Accessibility Survey

City of Downey Pruess Avenue - Brookmill Road To Phlox Street

Date of Inspection
4/26/2017

Prepared By
Disability Access Consultants
(800) 743-7067

Change In Level South Of Cleeta Street @ 33.937567726592, -118.144352138042

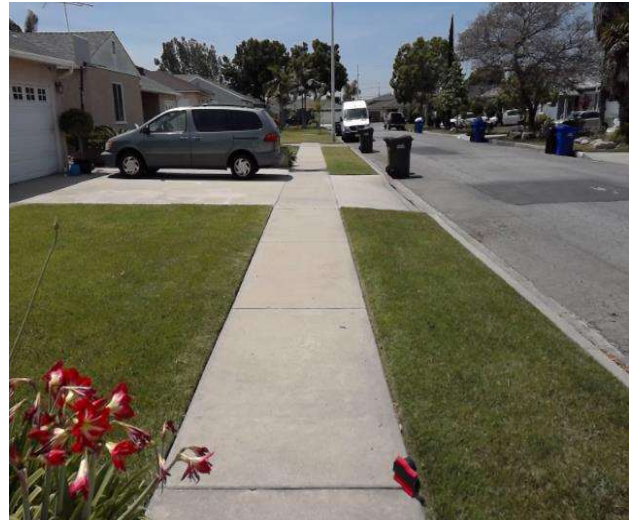
Sidewalks , Change in Level : Change in Level Non Beveled

Finding

There is a change in elevation greater than recommended value.

On-Site Finding 0.50 inches

Ensure that the change in elevation is within the recommended value.

Recommendation Up to 0.25 inches

Sidewalk North Of De Palma Street @ 33.937680103414, -118.144452720881

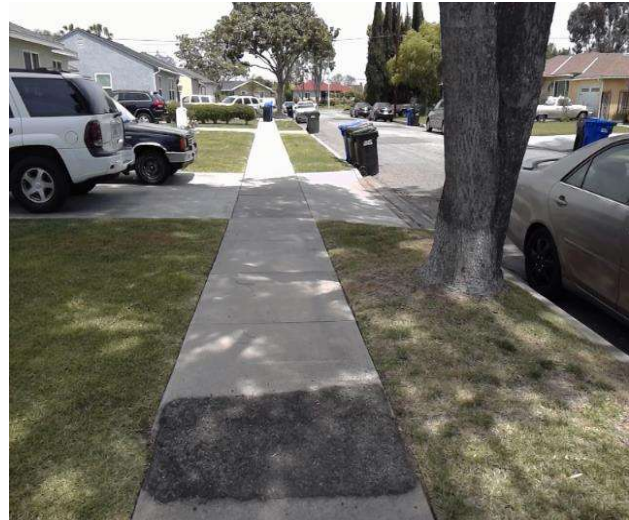
Sidewalks , Surface : Running Slope

Finding

Sidewalk running slope is not compliant.

On-Site Finding 13.30 percent for 2.50 feet

Notes : Surface is rough and uneven.

Repave the sidewalk surface with the recommended running slope.

Recommendation Up to 5.00 percent
